Service Info

Claas / Renault** - 228 0027 14 - 280/280 TGU6

New design / Neues Design / Nouvelle conception / Nuevo diseño / Nuovo disegno

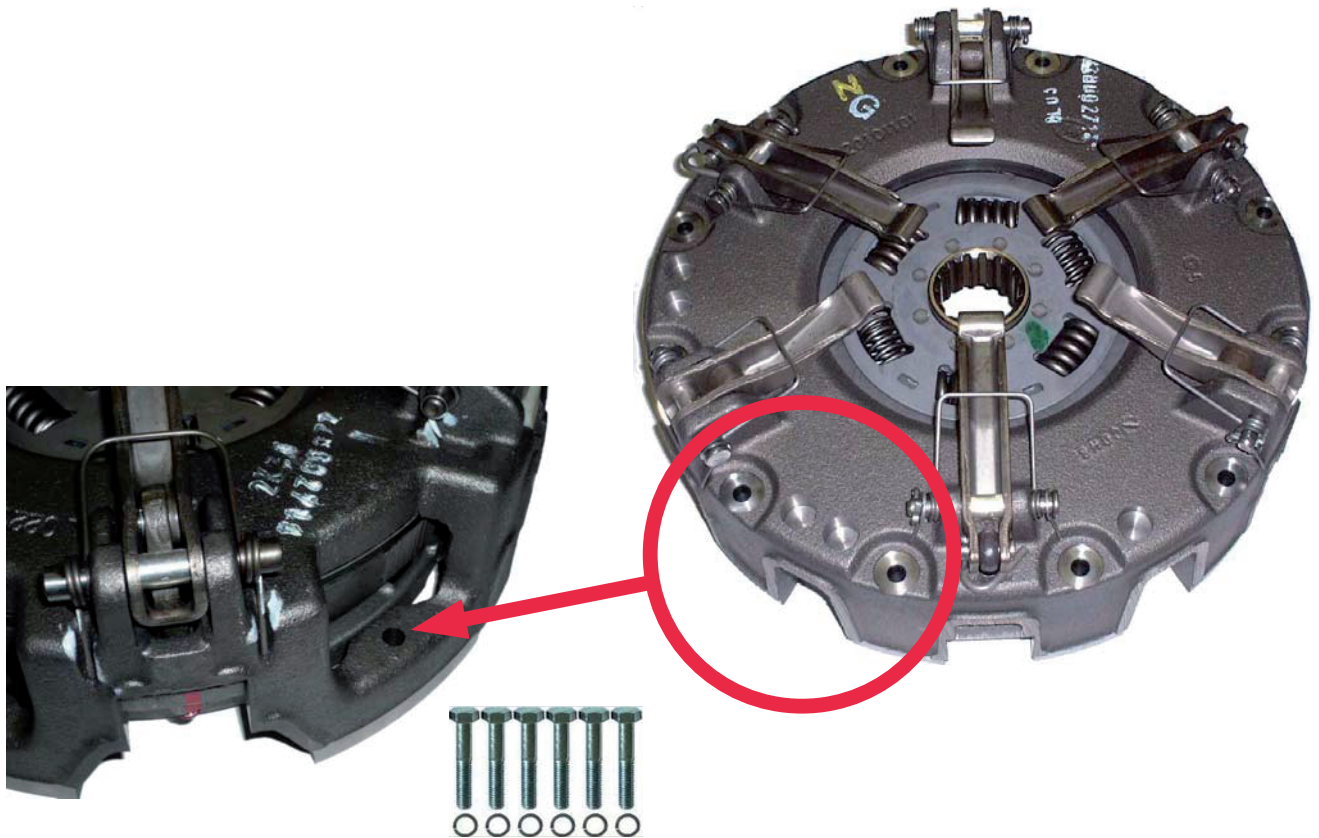
This new design utilises the latest clutch technology, using a vented housing for improved cooling and heat dispersal.

Fully interchangeable with existing clutches with no modifications required to vehicle or flywheel.

New fixation bolt set 6 x M8 x 1.25 x 50mm is supplied with new designs to accommodate the lower housing.
